October 10, 2023

RE: CYPRESS CREEK GOLF COURSE PROPOSED REDEVELOPMENT

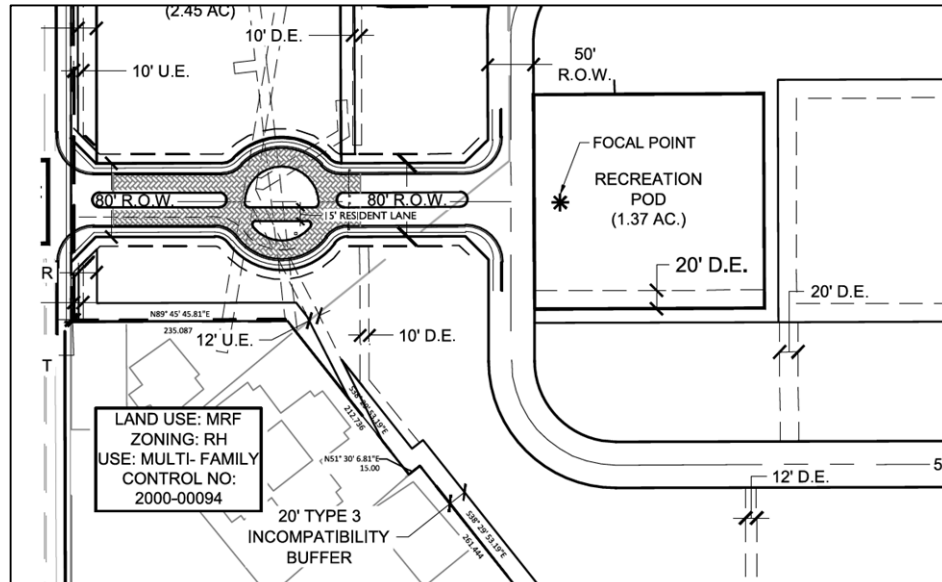
6. **Lakes and retention ponds should be more evenly distributed throughout the proposed development to increase the compatibility buffers and distribute retention basins to better accommodate stormwater runoff.** The proposed site plan has lakes and retention ponds concentrated on the east half of the golf course. The west side of the proposed infill development is largely impermeable surfaces that will no longer absorb surface water and proposes limited ponding to accommodate the substantial runoff that will be generated in this area. This distribution of ponding may also be necessary to accommodate the drainage from the surrounding neighborhood as required by the decades old South Florida Water Management District's single drainage permit. This permit identifies the golf course as the drainage basin for the entire neighborhood of surrounding homes. There is existing drainage from the surrounding neighborhood into lakes that are proposed to be removed.

Response: We understand the concerns you raised during the meeting related to historic drainage flow for your community and use of the golf course for drainage purposes. All lakes are inter-connected, and the drainage system has been designed to accommodate historic drainage flow and the new development. We also appreciate some of the information you shared concerning proposed lakes on the southeast side of the property. We are currently conducting further investigation and following up with appropriate regulatory agencies to ensure these issues are satisfactorily addressed.
